U.S. Department of Labor
Solicitation No. DOL099RB20702
New Dormitory Buildings
St. Louis Job Corps Center
St. Louis, MO

Amendment No. 2

Table of Contents

BUILDING SIGNAGE LOCATION

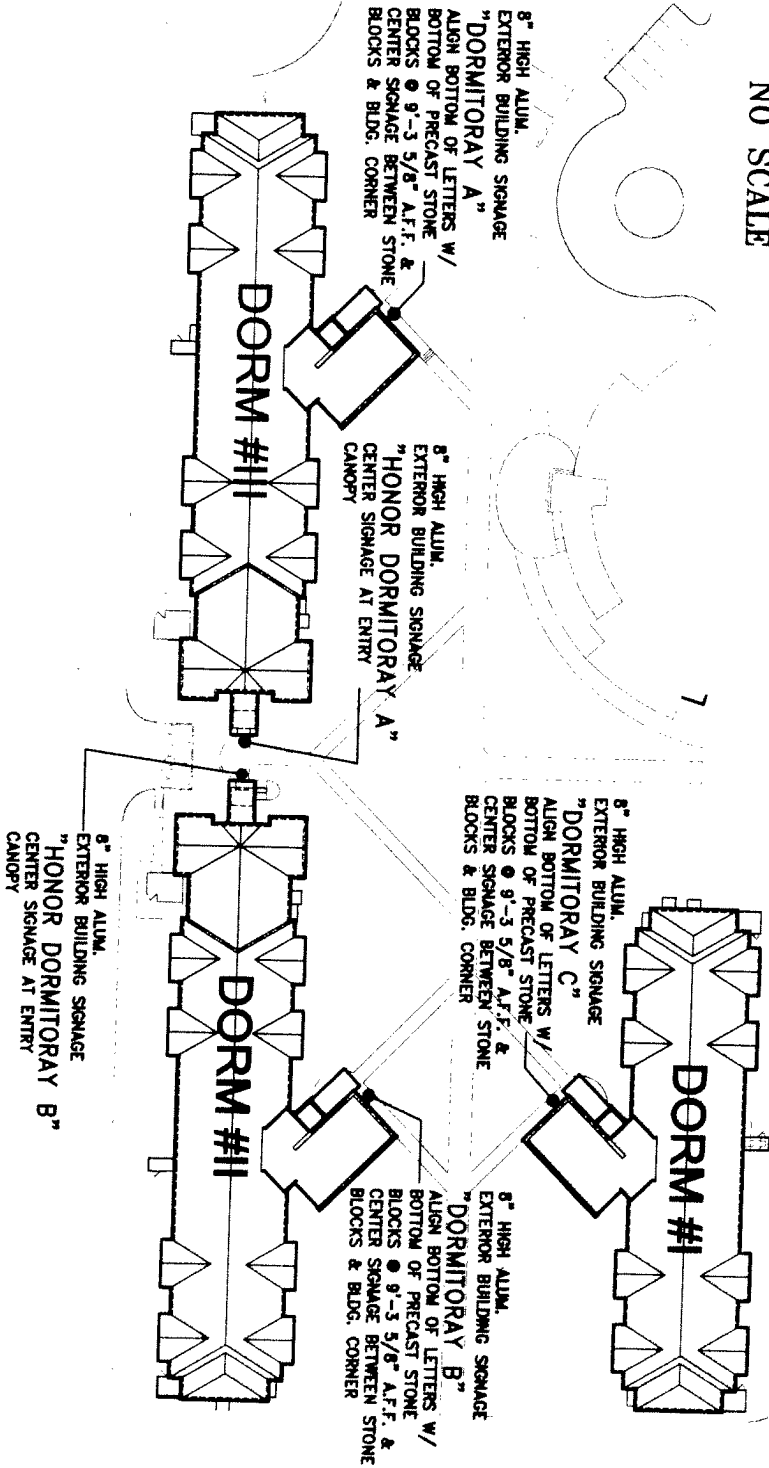
- EXTERIOR SIGNAGE SYSTEM:**
1. CAST ALUMINUM IN CLEAR ANODIZED FINISH.
 2. LETTERSTYLE: TIMES BOLD.
 3. LETTER CAP HEIGHT: 8".
 4. LETTER DEPTH: 3/4".
 5. MOUNTING METHOD: PROJECTING.

Comm. No. 12040	Drawing No.
Date 7-9-09	AMEND #2-3

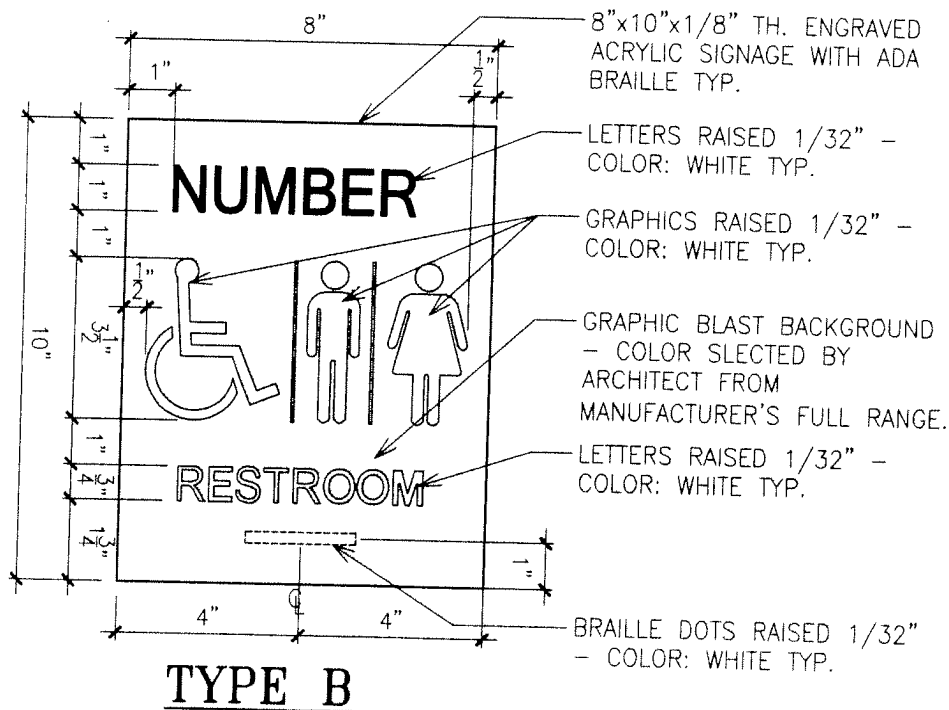
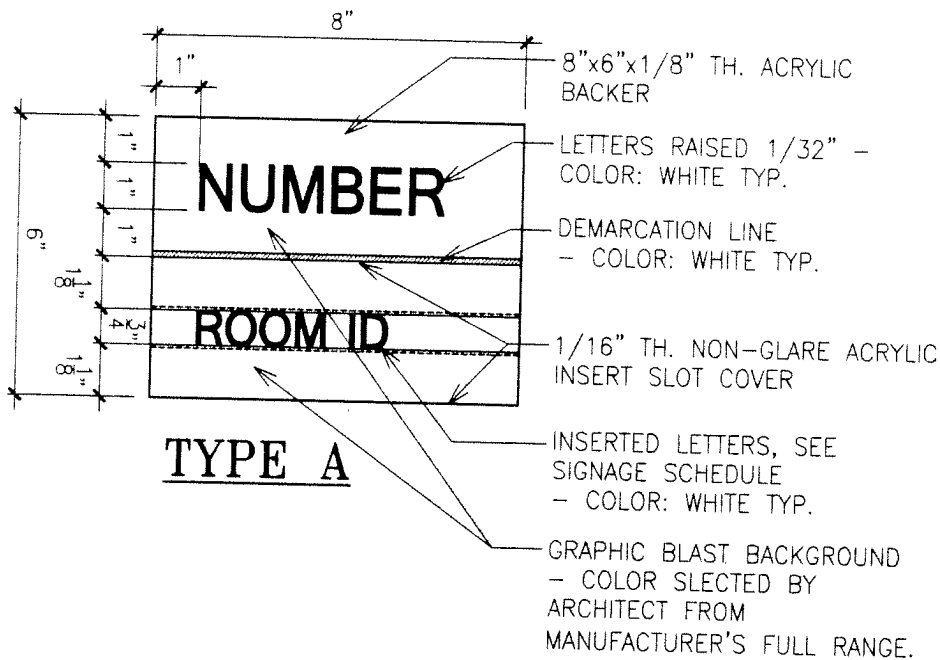
NOTE: THIS DRAWING SHALL SUBSTITUTE SIGN DTLS.
1/A2-1, 2/A2-1 & 3/A2-1 OF SHEET A2-1

NOTE: 1. SIGNAGE SHALL BE INSTALLED ALONG THE CENTERLINE OF DOOR OR 1" FROM BORROW LIGHTS AT A HEIGHT OF 60" A.F.F. TO THE CENTERLINE OF SIGN.

2. ALL LETTERS, NUMBERS AND SYMBOLS SHALL CONTRAST WITH THEIR BACKGROUND, LIGHT CHARACTERS ON A DARK BACKGROUND. CHARACTERS AND BACKGROUND SHALL HAVE A NON-GLARE FINISH.

3. ROOM ID INSERTS SHALL BE PROVIDED BY SIGNAGE CONTRACTOR AND MATCH SIGNAGE SCHEDULE. WHERE ROOMS ARE NOT ASSIGNED ROOM ID, CONTRACTOR TO PROVIDE BLANK ID INSERTS FOR FUTURE USE.
